Subject: AP1000 Response to Request for Additional Information (SRP6.2.2)

AP1000 TECHNICAL REPORT REVIEW**Response to Request For Additional Information (RAI)**

RAI Response Number: RAI-SRP6.2.2-CIB1-31
Revision: 1

RAI Response Number: RAI-SRP 6.2.2-SPCV-25
Revision: 2

Figure 2 – Refueling Cavity Drain Line Check Valve, Swing Disc Type

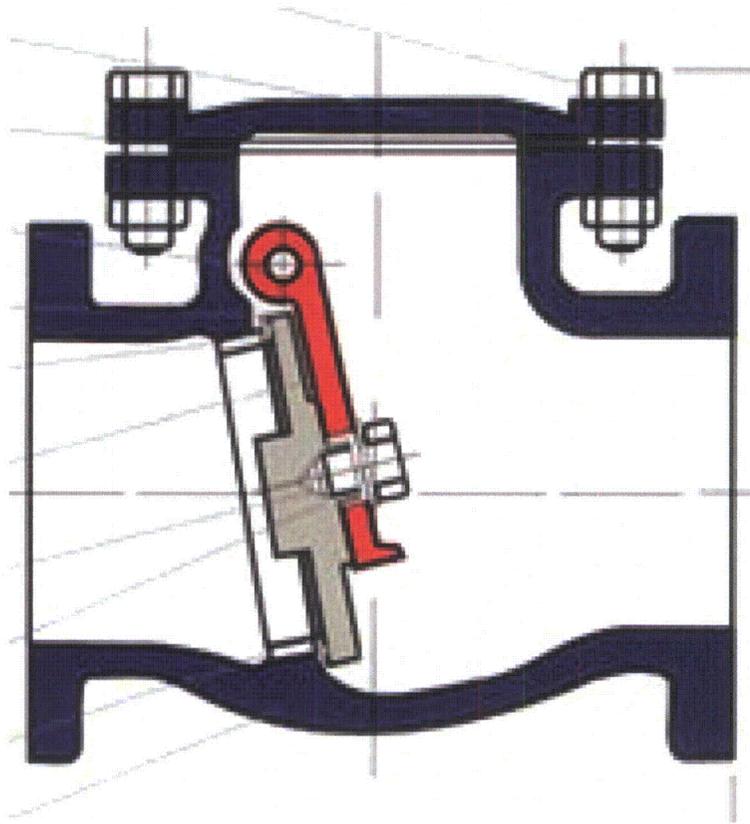
Finally, even if some MRI fines were transported into the drain lines the flow passage through the type of check valve used in this line (swing disc check valve) is not conducive for trapping debris and it is expected that MRI fines as well as latent debris would get carried through. Figure 2 shows a typical swing disc check valve. This line uses 6 inch check valves that are designed to have an low leak rate, []^{a,c}; each of these check valves is tested in the factory prior to their installation in the plant to verify that their leak rate less than or equal to this value. Although the leakage through these check valves may not be this low in the plant, they will certainly be less than the []^{a,c} gpm discussed below. This line has two series valves which contribute to the low probability of significant leakage. These valves currently have inservice testing requirements that stroke each valve open and closed every refueling outage. During this IST, the operation of the check valves is monitored using non-intrusive sensors that verify that the valves operate normally (the disc moves freely, opens and returns to the full closed position). Because of the large margin between the design leak rate and the allowable leak rate these check valves are not subjected to inservice leak rate testing.

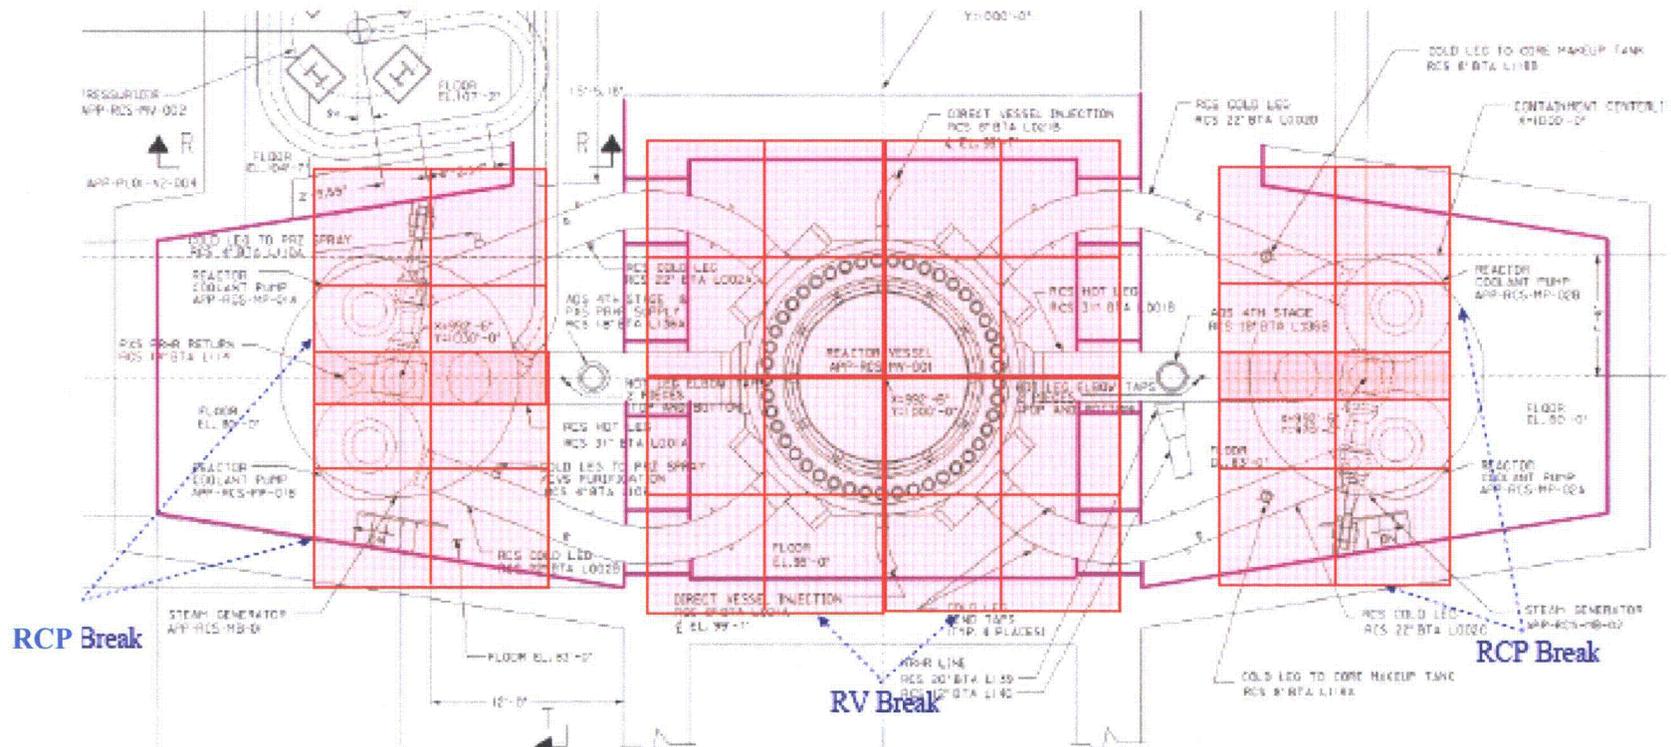
The specific break locations quantified for the CLs and HLs were at the terminal ends. Figures 1, 2, and 3 show these break locations and the associated 4 D ZOIs that are used to quantify the amount of epoxy coatings.

For these two CL break locations in the AP1000, the limiting amount of CL ZOI coatings results from a break located at the CL connection to the reactor coolant pump. The coating surface areas within this CL break ZOI were calculated for the AP1000 to be [

Figure 3 - CL and HL Breaks Section View, Terminal End Break ZOIs

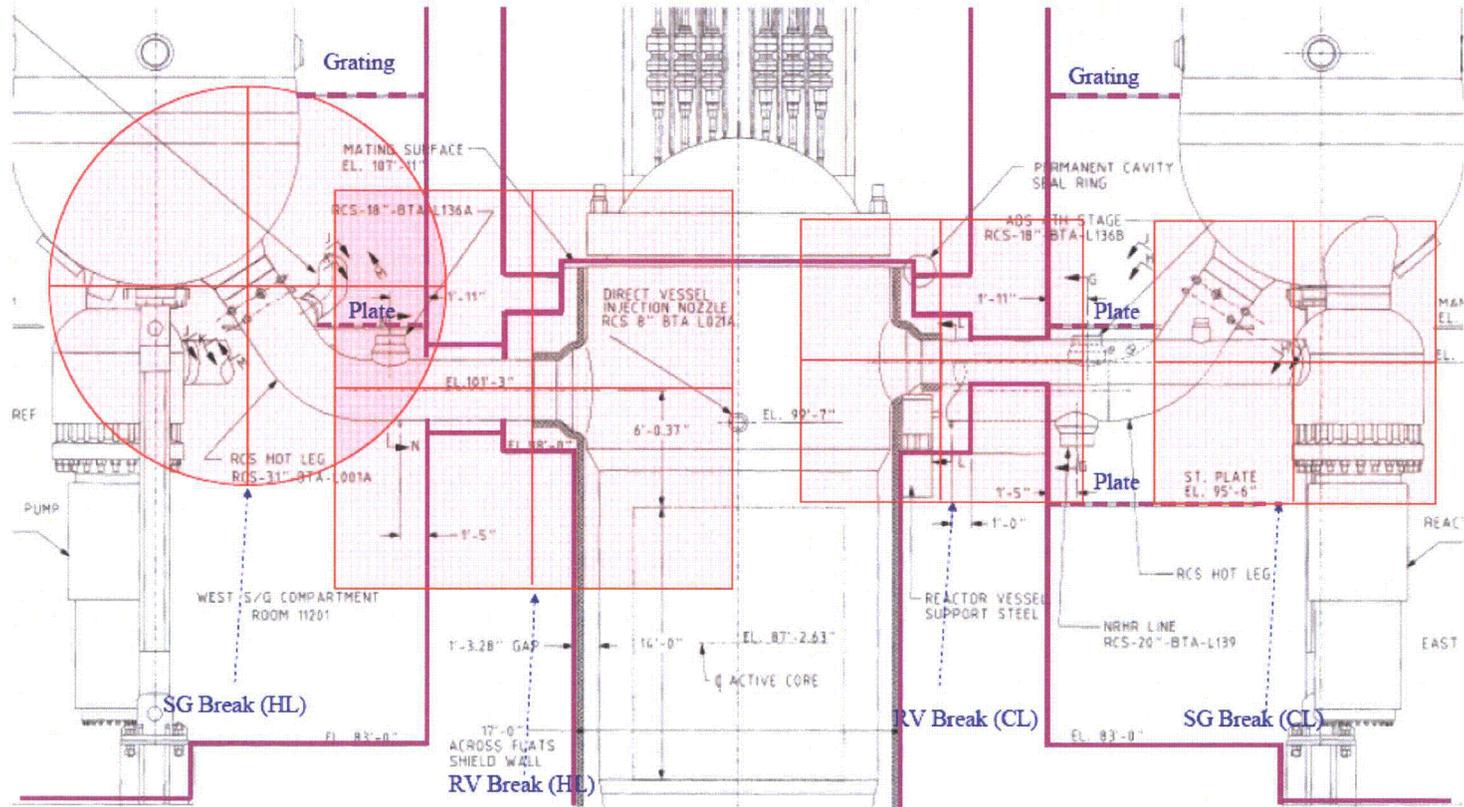
Note, in figures 3, 7, and 12 the grating is galvanized and plates are epoxy coated carbon steel.

Figure 4 - CL Breaks Every 5' From RCPs Plan View

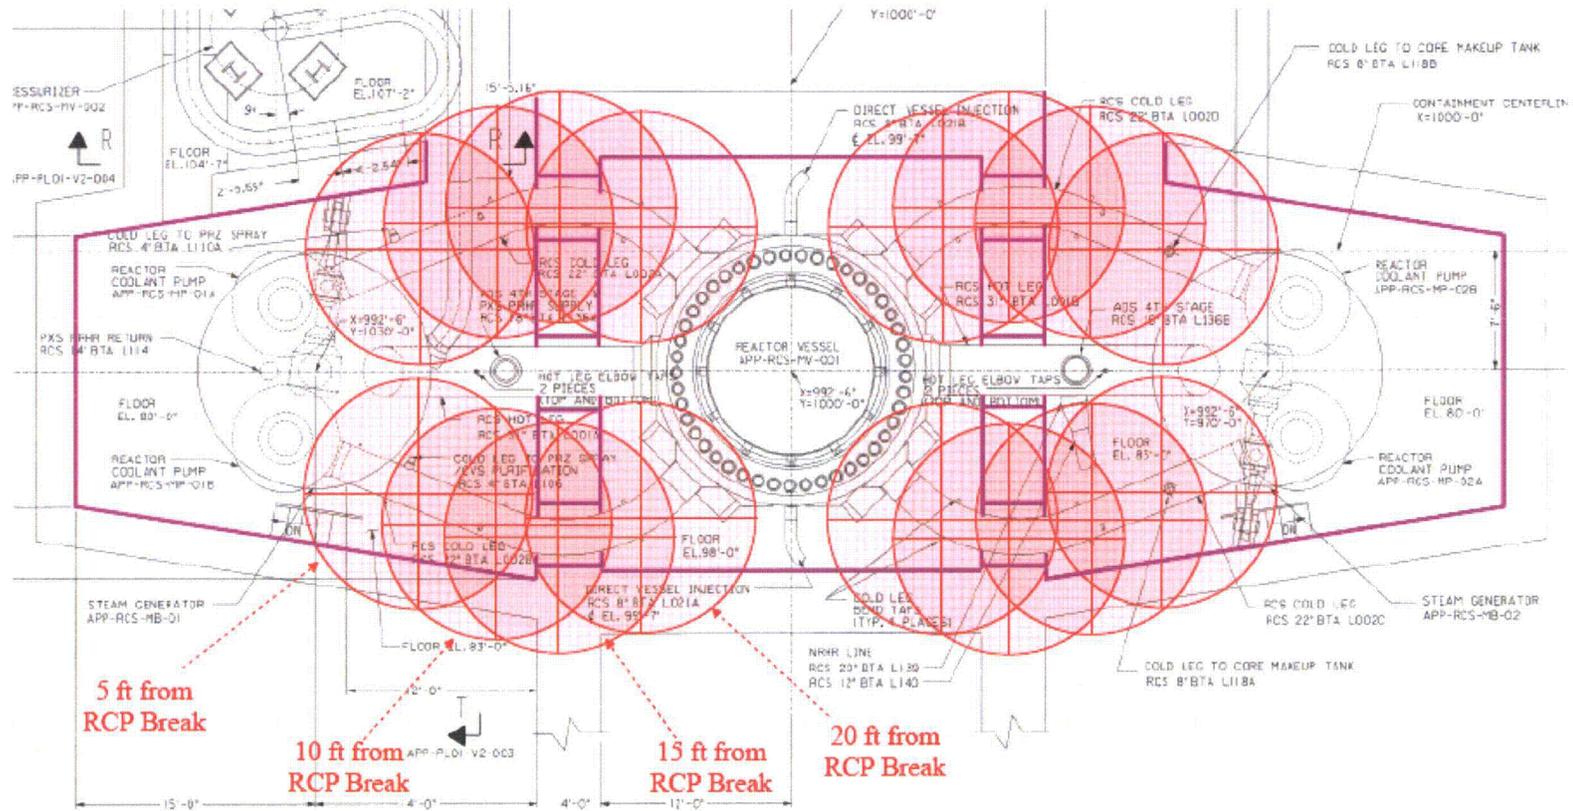
The length of CL and HL lines within the loop compartment are greater than 5' so in order to provide additional evidence that the terminal end break locations are limiting, break locations every 5' have been evaluated, in accordance in the NRC guidance contained in the SE to NEI 04-07. Figure 4 shows the CL pipe break locations every 5' from the RCPs. Figure 8 shows the HL pipe break locations every 5' from the SGs.

From inspection of these break locations and the quantified terminal break location it is obvious that the CL breaks located at 15' and 20' are not limiting. The break at 15' is inside the bio-shield wall such are very little coatings would be located within the ZOI. The break location at 20' is near to the RV terminal end and since the RV terminal end break only had less than 30% of the coating surface area of the RCP terminal end it is concluded that it

Figure 5 - CL Breaks At RCP and 5' / 10' Plan View

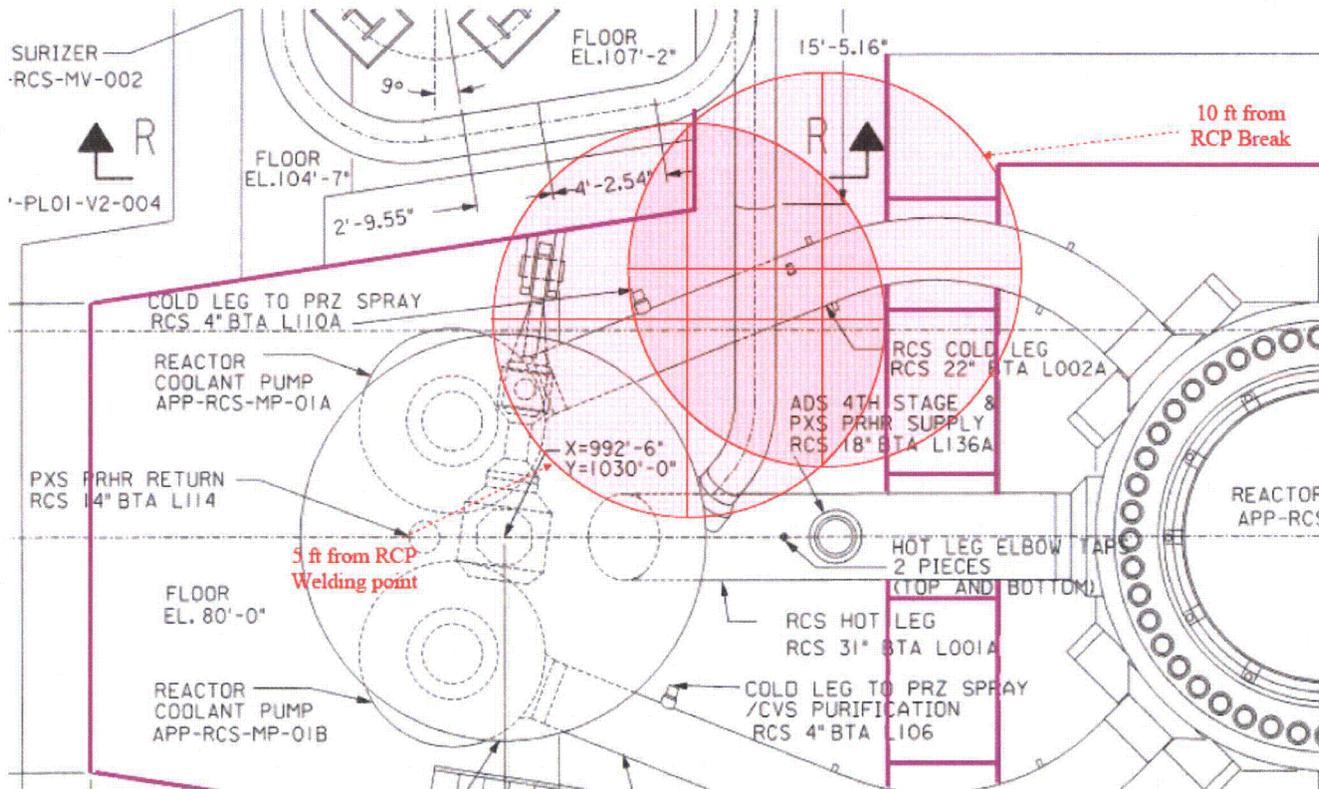
The CL breaks at 5' and 10' from the RCP are shown on figure 5; these figures show how the ZOI intersects with the loop compartment walls. Figure 6 shows how these ZOIs intersect with the platform located at the 104 ft 5.5 in. elevation. In figure 6 all break ZOIs are shown as a square because this was the shape used to quantify the length of the beams and platform surface areas. Note that the side of the square is conservatively set equal to the ZOI diameter. Figure 7 shows a section view that illustrates these ZOIs. An estimate was made of the changes that would occur in the coating surfaces within the ZOIs for these two break locations (5' and 10' from the RCPs). For example, the wall surface areas decrease by ~70 ft² at the 5' break and increase by ~40 ft² at the 10' break. The wall surface area decreases from the terminal end break to the 5' break because the terminal end break used a square ZOI, shown in Figure 1, which occupied more wall than did the sphere ZOI that was used at the 5' break, shown in figure 5. This was done to be conservative with the calculations. The 5' break ZOI will only come in contact with the side wall as did the break at the terminal end, but of a smaller area. The 10' break calculated by a sphere ZOI increases in wall area over the terminal end and 5' break because it will become in contact with both side wall and bio-shield wall between the loop compartment and RV. At both 5' and 10' breaks the amount of a platform plate increases by ~40 ft². Figure 6 shows exactly where the platform plate is positioned and shows when the break location is moved that more plate will be occupied. On the other hand, the amount of beam surface area []^{a,c} for the 5' and 10' break locations. Also the amount of pipe surface area []^{a,c} for the 5' and 10' breaks. The net effect of these changes is that the total area is estimated to []^{a,c}.

Figure 9 - HL Breaks At SG and 5' / 10' Plan View

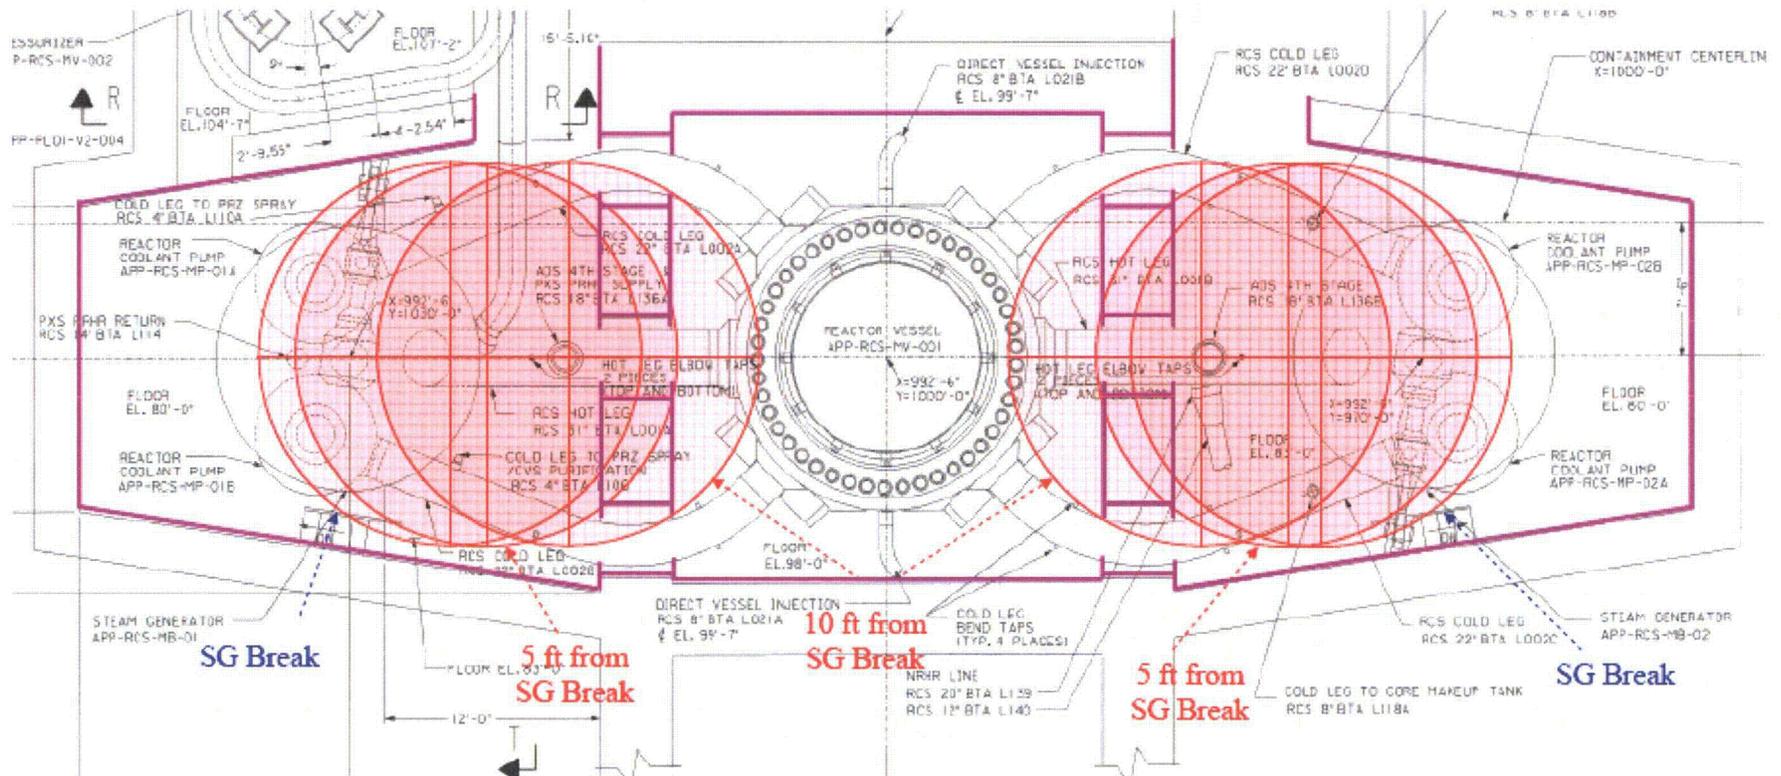
The HL breaks at 5' and 10' from the SG are shown on figure 9. In comparing these two breaks it can be seen from figure 12 that both of them are at a lower elevation than the SG terminal end such that the maintenance platform and structural beams located at elevation 116 ft 5 in. will no longer be within the ZOI. In addition, the break at 10' is closer to the RV bio-shield wall and therefore will have a larger wall surface area than the 5' break. As a

result, only the 10' HL break location will be evaluated. This break location is shown on Figure 9 along with the SG terminal end location. In figure 10 and 11 the SG terminal end break ZOIs is shown as a square because this was the shape used to quantify the length of the beams and platform surface areas. Note that the side of the square is conservatively set equal to the ZOI diameter. Figure 11 shows these break locations at the 104 ft 5.5 in. platform elevation. Figure 10 shows these break locations at the 116 ft 5 in. platform elevation; note that at this elevation none of the platform is within the 10' break ZOI. For the 10' break location, the upper platform being outside the ZOI [

Figure 10.3.2-1 (Sheet 1 of 2)

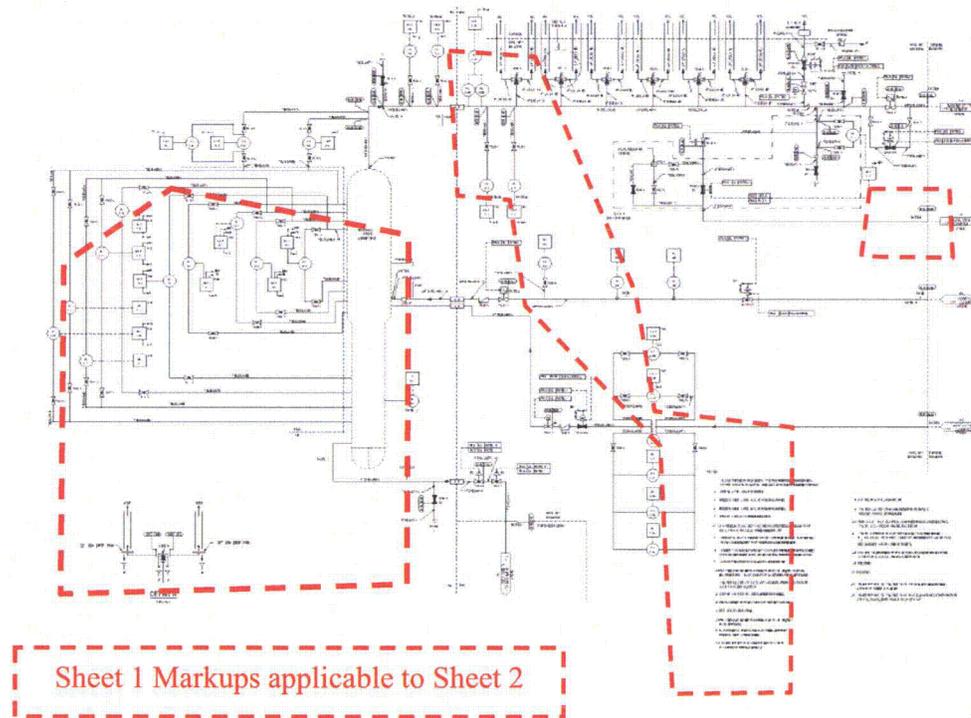
- d) DCP-1510 (APP-GW-GEE-1510) was approved by the Westinghouse Change Control Board (CCB) on April 23rd, 2010. The DCP changed all Steam Generator System (SGS) ASME Section III instrument piping to stainless steel. The DCD changes resulting from DCP-1510 will be submitted to the NRC staff and included in the amendment request for the certified design (DCD Revision 18). The change to stainless steel instrument piping was made due to corrosion concerns. The welding of dissimilar metals in the SG is not different from what is already standard practice in the pressurizer where SS instrument pipes are welded to a CS pressure vessel. The DCD markups associated with DCP-1510 (APP-GW-

Sheet 1 Markups applicable to Sheet 2

In-addition to those proposed in RAI-SRP 6.2.2-SPCV-25, Rev 1, see changes to Figure 10.3.2-1.

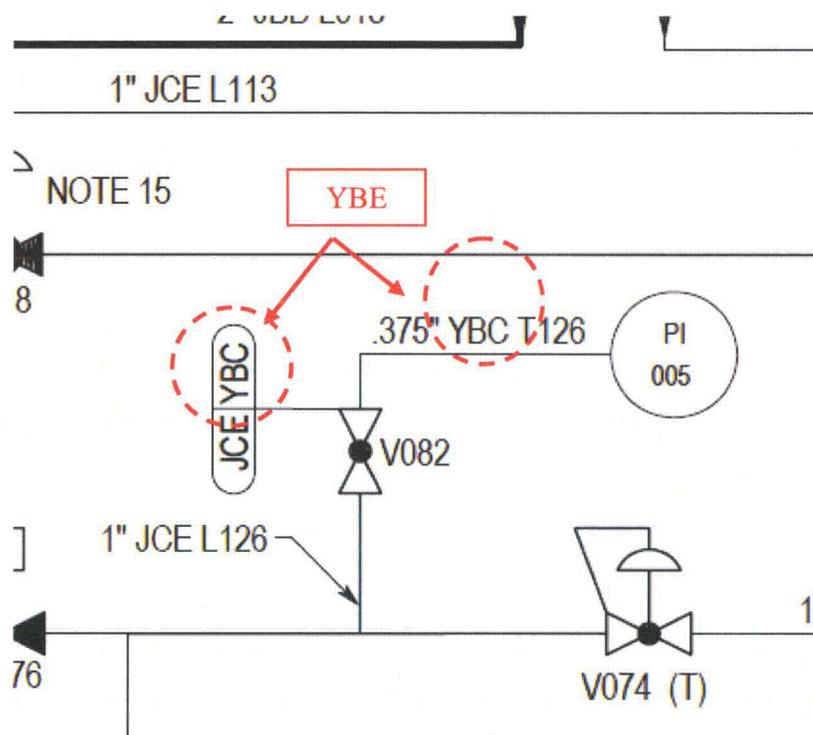
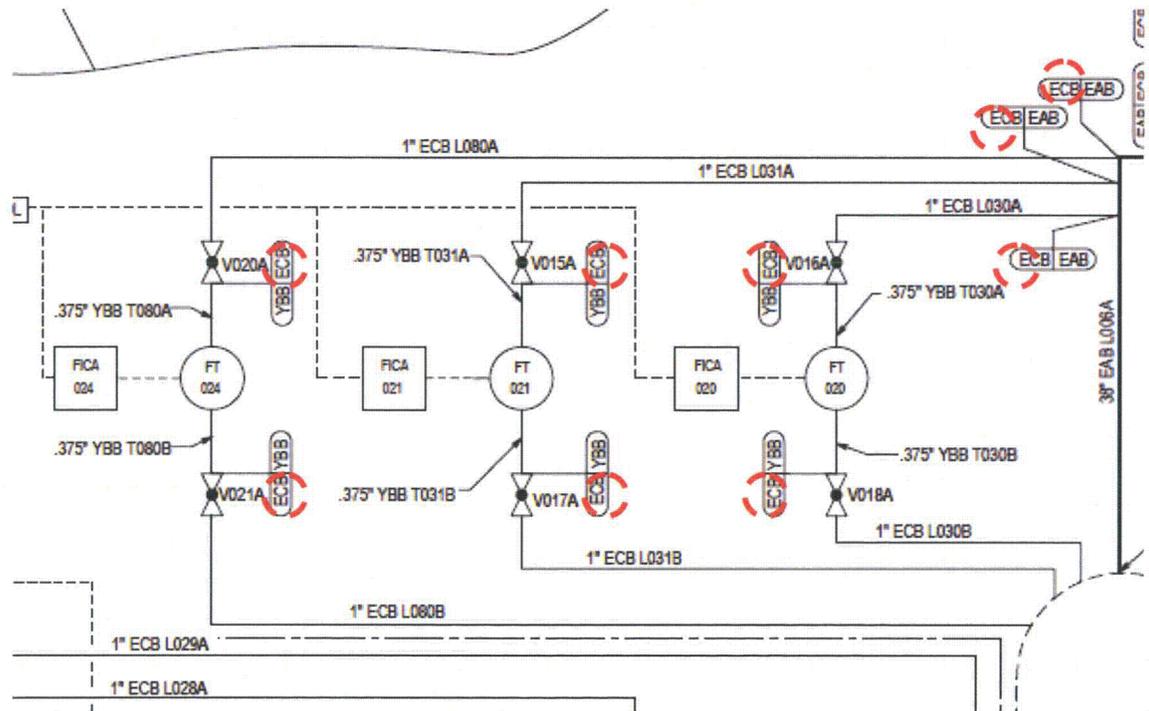
Change:
All highlighted line classes to be changed to 'CBB'
